Modification of approval marks.
 Slight modification on the lateral indentation.

| 4754 Strip Block | | | | | 0118.2241 | |

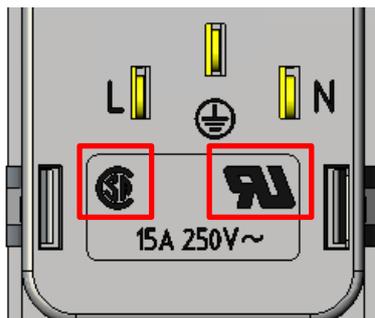
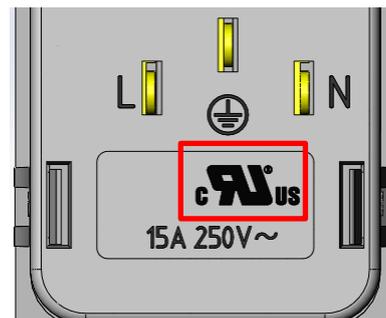
New combined cURus approval mark instead of separates UR and CSA marks.
 Slight modification on the lateral indentation.

Old marking

New marking

Old form

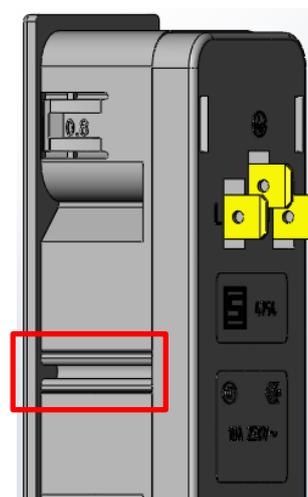
New form

Consolidation of North American approval marks with the combined cURus mark.
Slight modification on the lateral indentation because of optimization of the injection process.

Form: Yes Slight modification on the lateral indentation.
Fit: No There are no dimensional changes.
Function: No No change on the specification.
Production Site: No There is no change of the production site.
Product Label: Yes CSA and UR marks replaced by cURus mark.
